SUBJECT: Significant hazards evaluation for FH/FQ proposed amend to
 Licenses DPR-31 & DPR-41 dtd 830819.

Re: Turkey Point Units 3 & 4
Docket Nos. 50-250 & 50-251
Proposed License Amendment
F_ΔH/F_Q

Significant Hazards Evaluation

Turkey Point Units 3 & 4

Figure 3.2-3

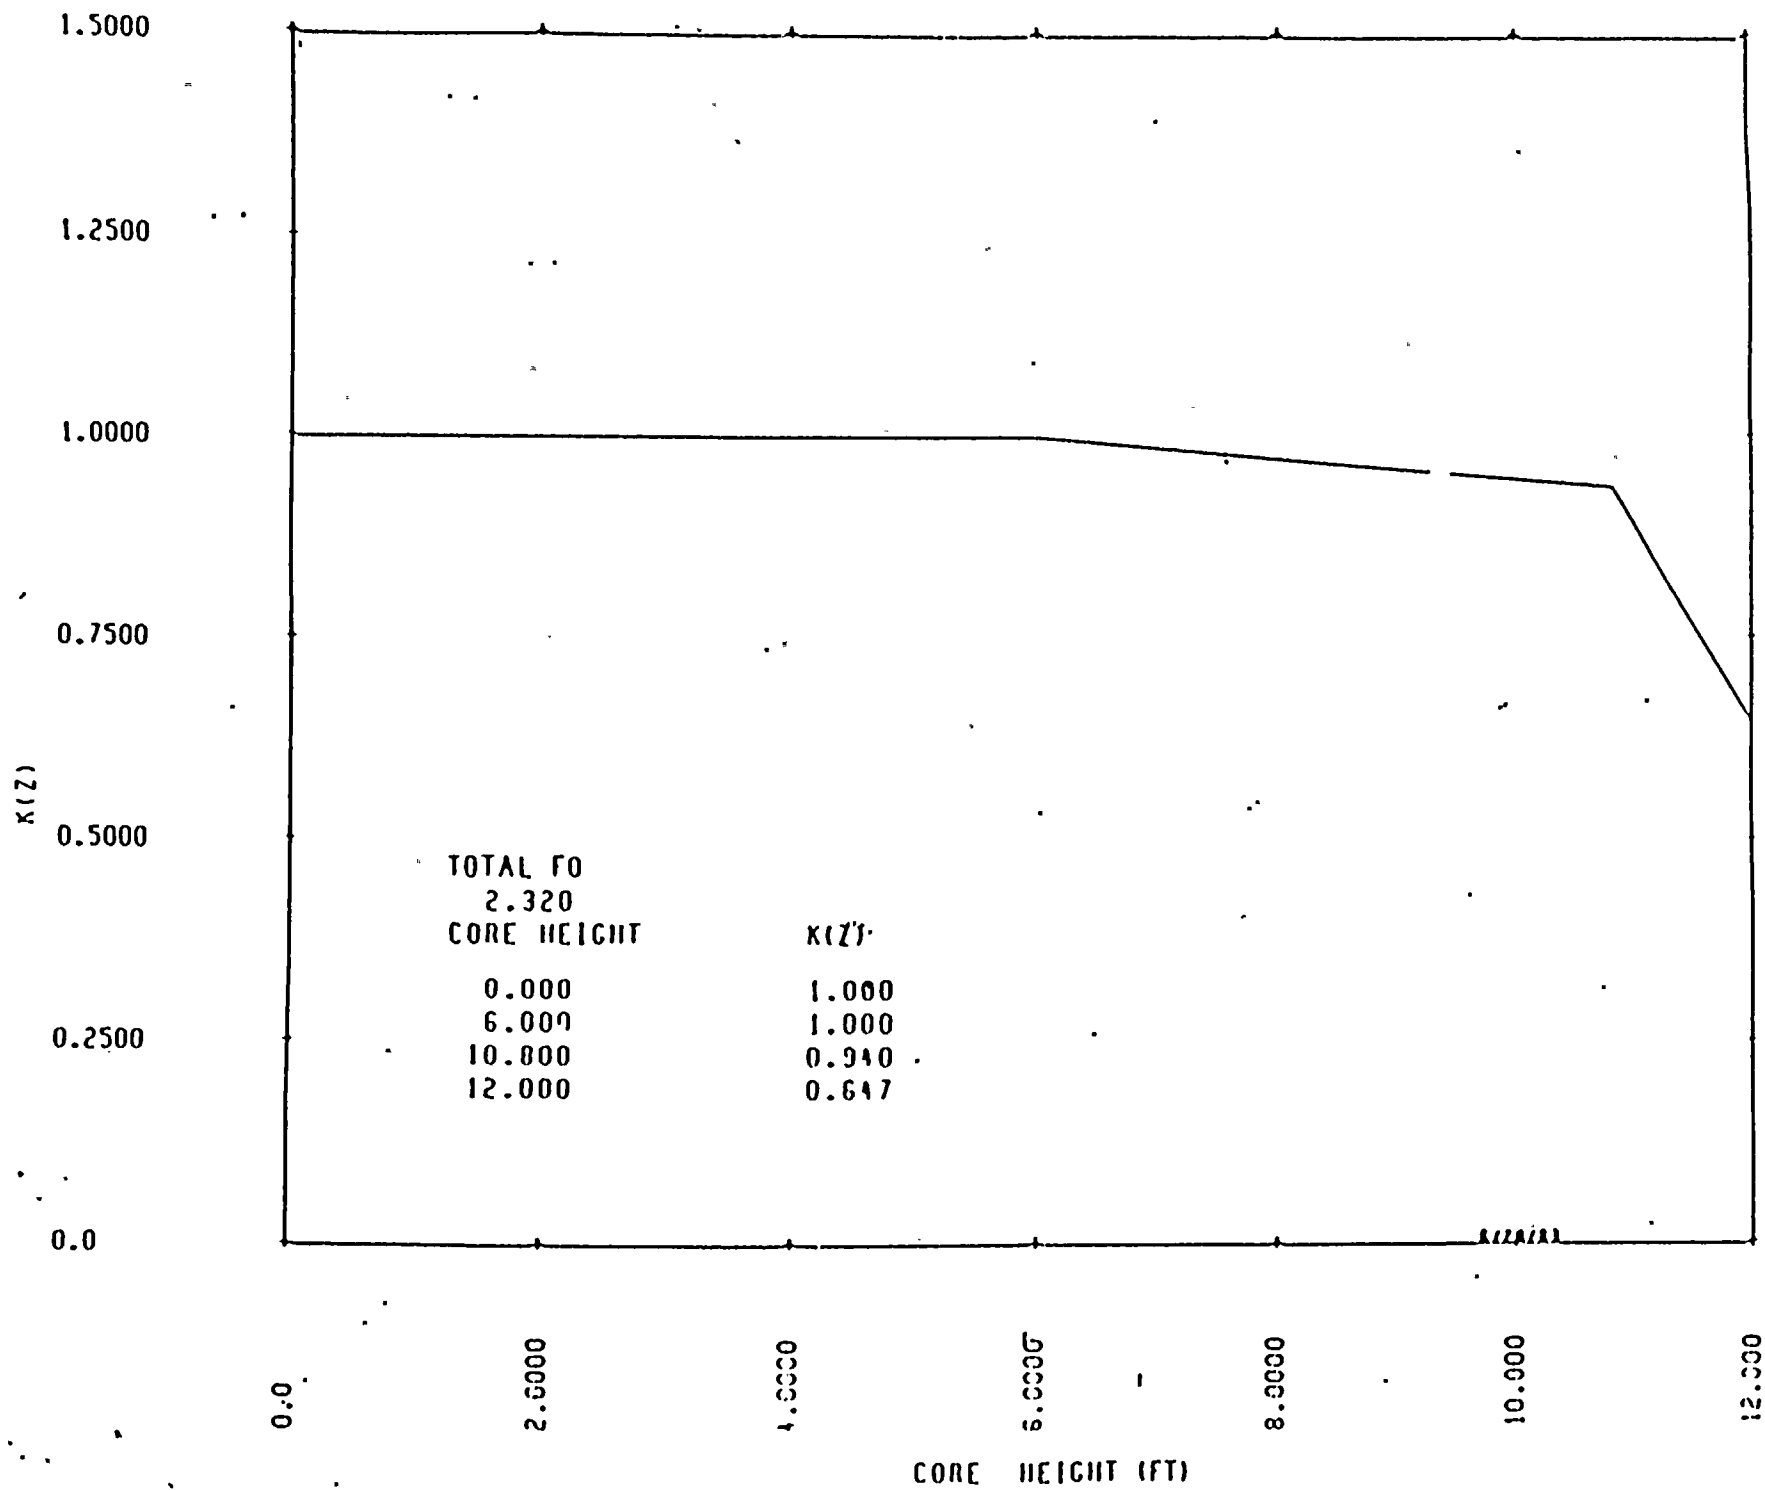
1. The hot channel factor $F_{\Delta H}$ limit is increased from 1.55 to 1.62.
2. The total peaking factor F_Q limit is increased from 2.30 to 2.32.
3. The Overpower ΔT setpoints and thermal-hydraulic limit curves are made more conservative.

List of Figures
Page 2.3-3
Figure 3.2-3
Page B2.1-2

Replace page
Replace page
Replace page
Replace page
